PCN# 20240402000.1

**Qualify HFTF as an additional Assembly site for select devices
Change Notification / Sample Request**

PCN Number:	20240402000.1	PCN Date:	April 10, 2024
Title:	Qualify HFTF as an additional Assembly site for select devices		
Customer Contact:	Change Management team	Dept:	Quality Services
Proposed 1st Ship Date:	July 09, 2024	Estimated Sample Availability:	May 10, 2024*
*Sample requests received after May 10, 2024 will not be supported.			
Change Type:			
<input checked="" type="checkbox"/> Assembly Site	<input type="checkbox"/> Design	<input type="checkbox"/>	Wafer Bump Material
<input type="checkbox"/> Assembly Process	<input type="checkbox"/> Data Sheet	<input type="checkbox"/>	Wafer Bump Process
<input checked="" type="checkbox"/> Assembly Materials	<input type="checkbox"/> Part number change	<input type="checkbox"/>	Wafer Fab Site
<input type="checkbox"/> Mechanical Specification	<input type="checkbox"/> Test Site	<input type="checkbox"/>	Wafer Fab Material
<input checked="" type="checkbox"/> Packing/Shipping/ Labeling	<input type="checkbox"/> Test Process	<input type="checkbox"/>	Wafer Fab Process

Package Outline Differences:

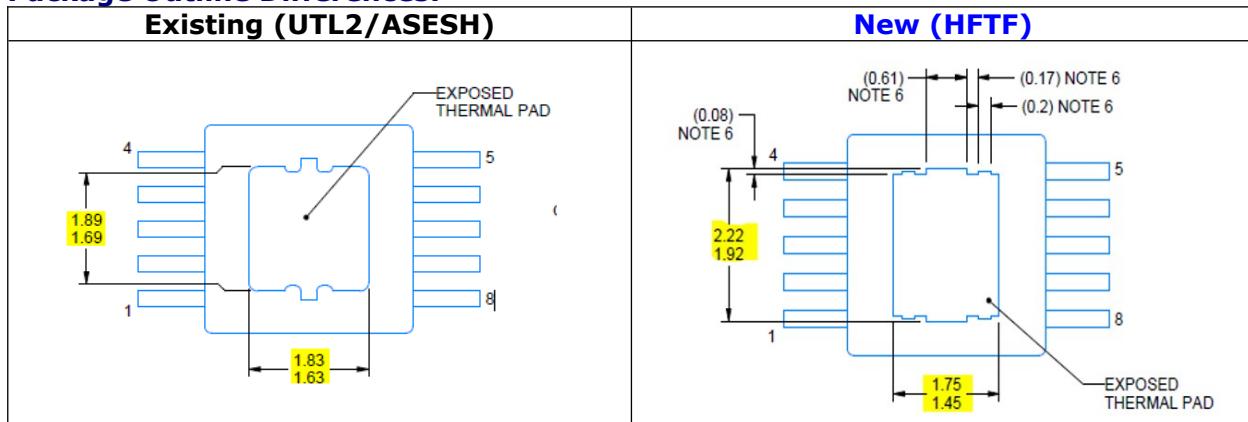
Texas Instruments is pleased to announce the qualification of HFTF as an additional Assembly site for the list of devices shown below. Material differences between sites are as follows.

UTL2	ASESH	HFTF
Wire type/diam	1.3mil Au, 1.3mil Cu	1.3mil Cu	1.3mil Au
Mount compound	PZ0013	EY1000063	A-24
Mold compound	CZ0094	EN2000515	R-32
